Service Letter No. 492

I General Instructions for Inspection and Operation of Landing Gear Selector Handle and Associated Link Rod to Powerpak

II Replacement of Nose Gear Idler Link Assembly

PA-31 Navajo

II - Replacement of Nose Gear Idler Link Assembly

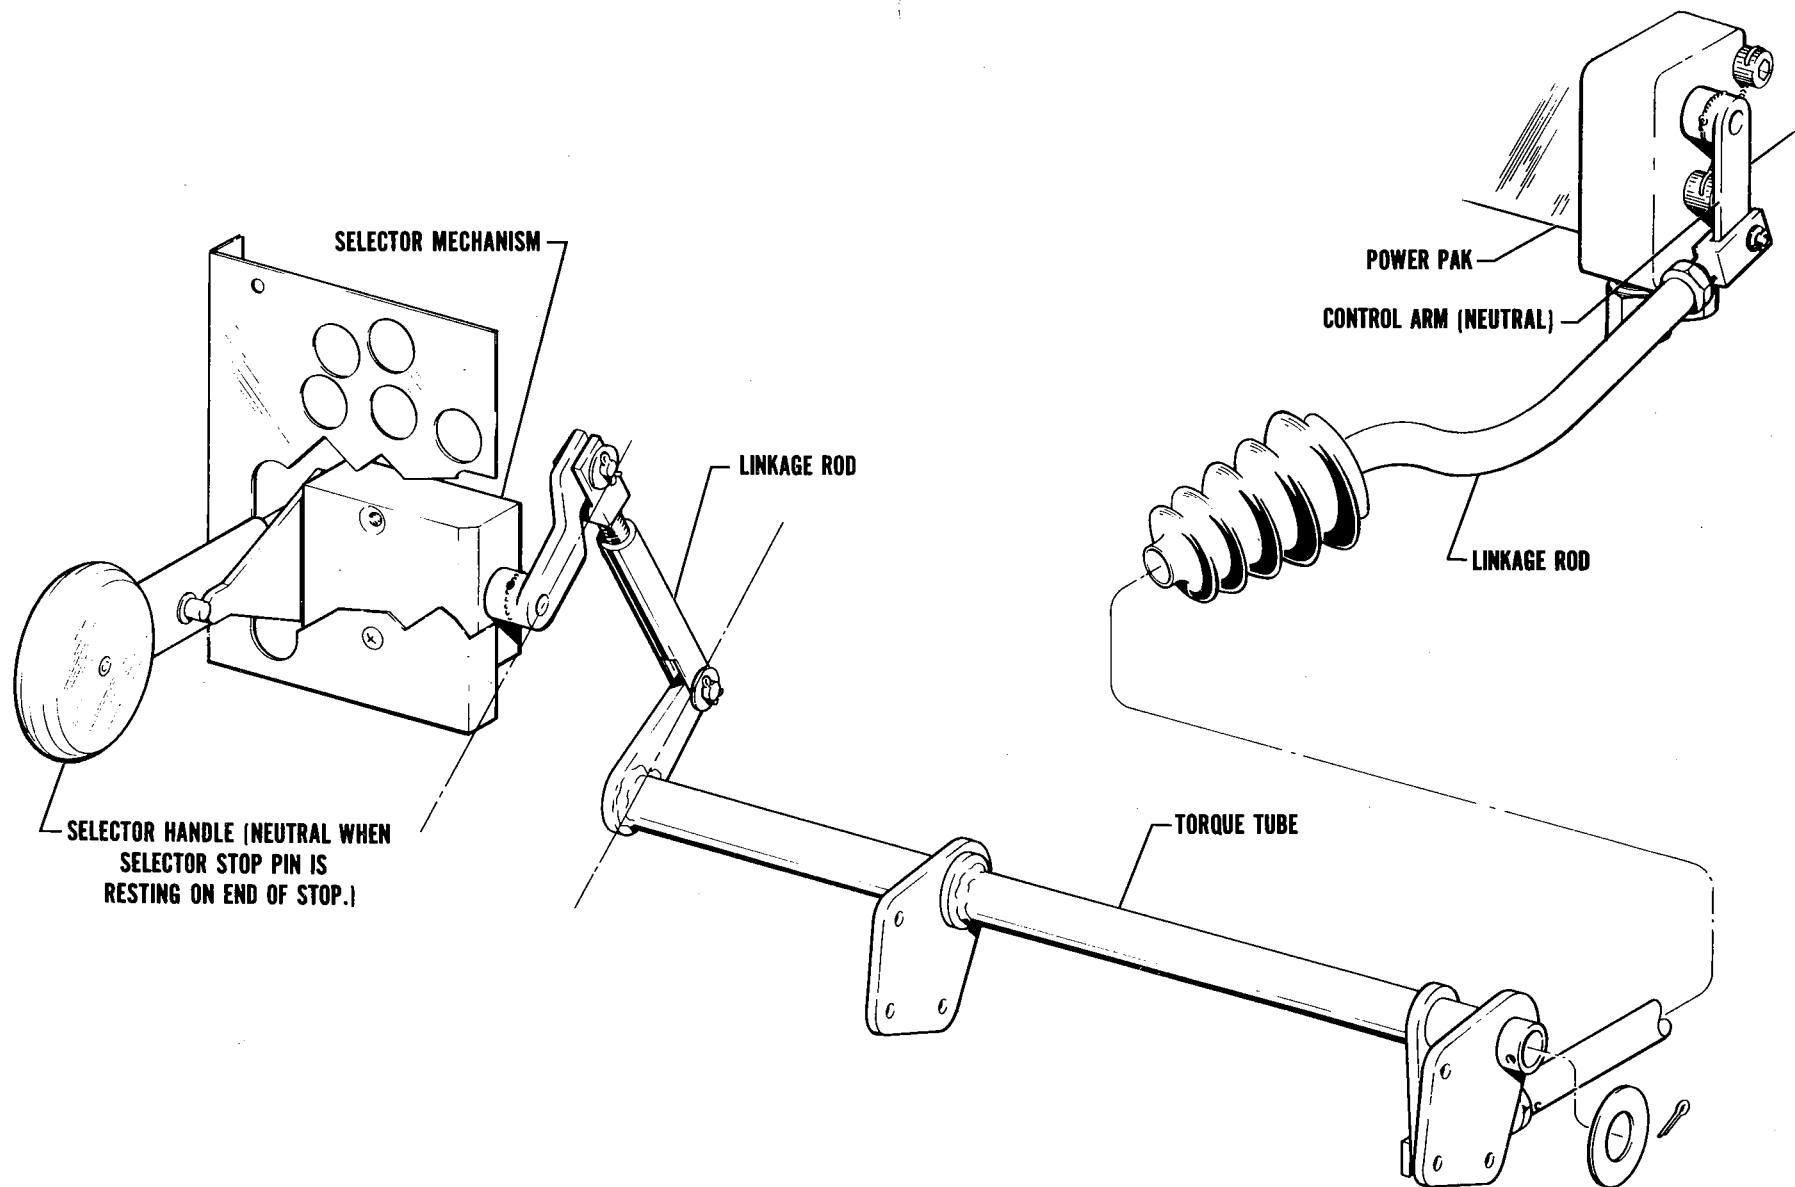
The Nose Gear Idler Link Assembly, part number 40296-00, must be replaced in the subject aircraft as soon as possible. NOTE: Aircraft must be placed on jacks prior to removal and replacement of Nose Gear Idler Link Assembly.

After installation of the link assembly, it must be adjusted in accordance with the Navajo Service Manual Page 7-11, paragraphs J and K. However, the through center figures called out in paragraph K shall be changed to .180 to .250 through center.
